TXX-2912

COMANCHE PEAK STEAM ELECTRIC STATION
TRANSMITTAL OF MATERIAL REQUESTED
BY QUESTION 032.1
FILE NO. 10010

032.0 INSTRUMENTATION AND CONTROL SYSTEMS BRANCH

Q032.1 Provide a listing of the sections of the FSAR which include the responses to the staff positions and questions transmitted to all applicants with RESAR-3 plants. This transmittal was dated November 17, 1977.

FIGURE Q032.1-18

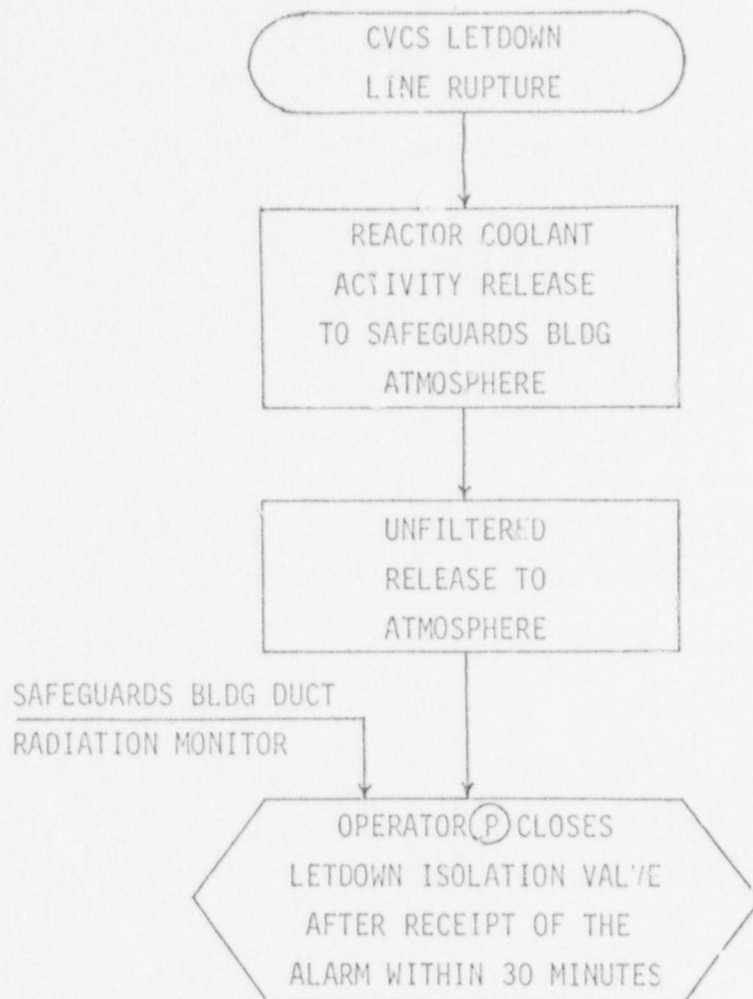
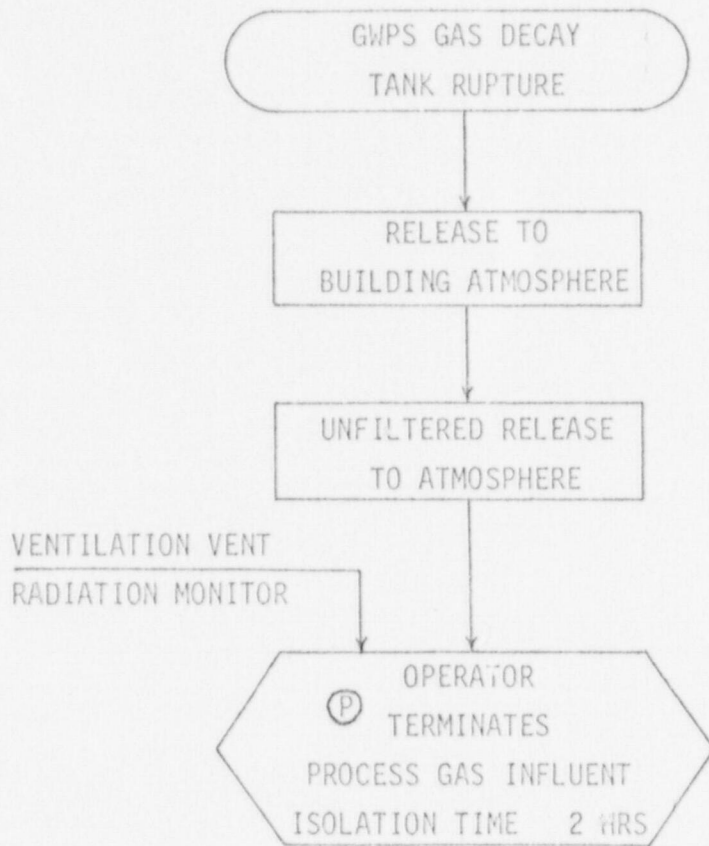
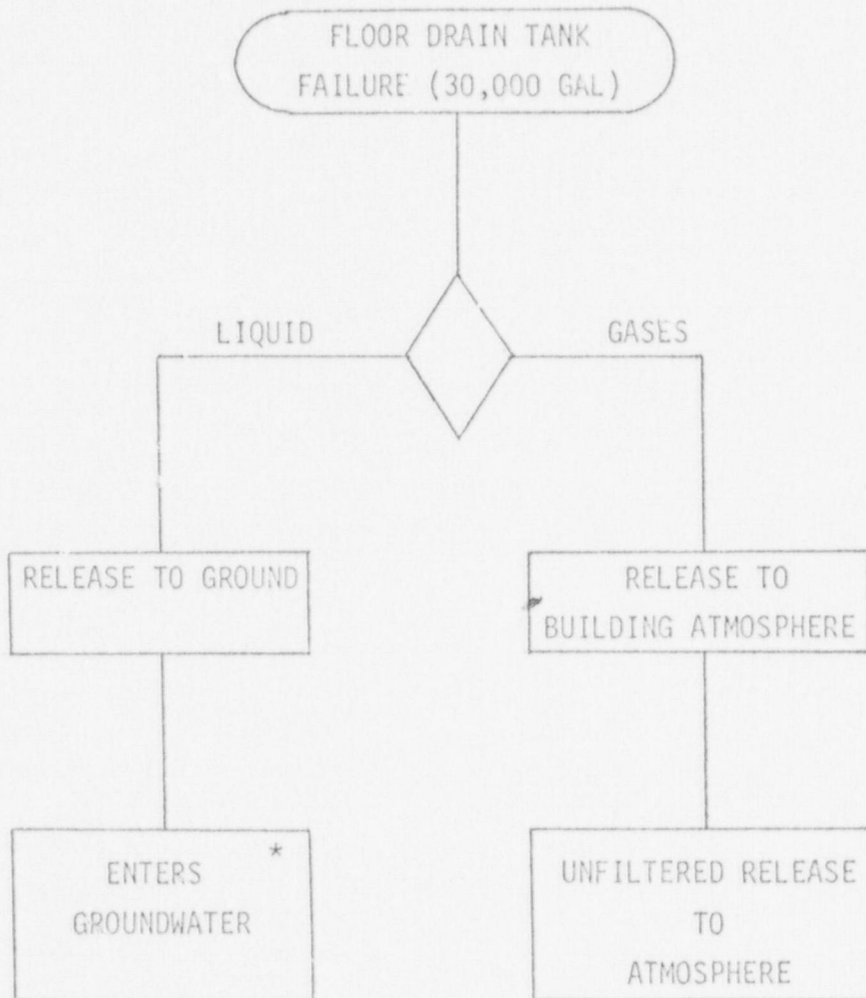
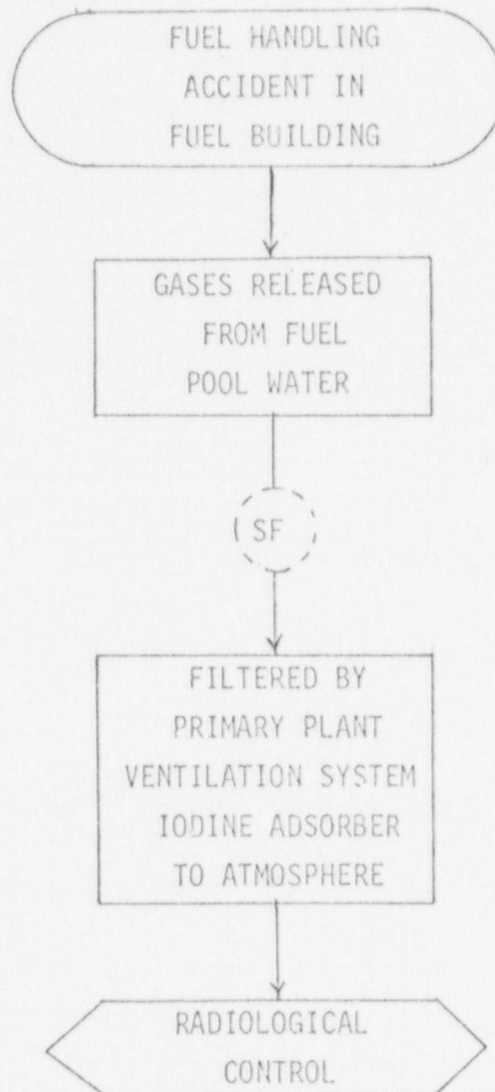
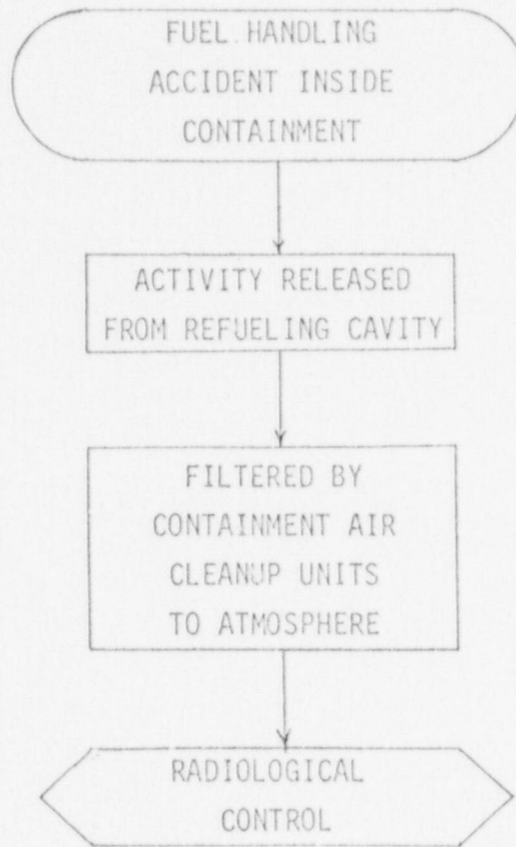
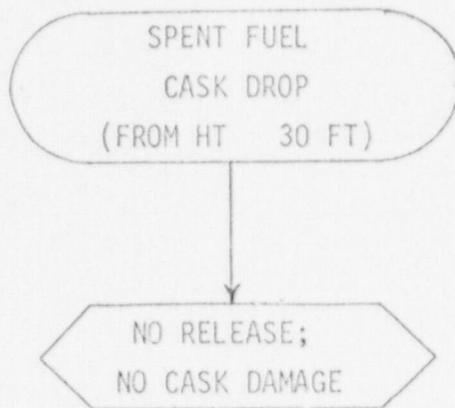
RESAR-3 For each transient and accident analyzed in Chapter 15,
(15.0.1) provide the following information:

- (1) The step-by-step sequence of events from event initiation to the final stabilized condition. This listing should identify each significant occurrence on a time scale, including for example: flux monitor trip, insertion of control rods begin, primary coolant pressure reaches safety valve set point, safety valves open, safety valves close, containment isolation signal initiated, containment isolated, etc. All required operator actions should also be identified.
- (2) The extent to which normally operating plant instrumentation and controls are assumed to function.
- (3) The extent to which plant and reactor protection

systems are required to function.

- (4) The credit taken for the functioning of normally operating plant systems.
- (5) The operation of engineered safety systems that is required.

Response These diagrams are given in Figures Q032.1-1 to Q032.1-24.
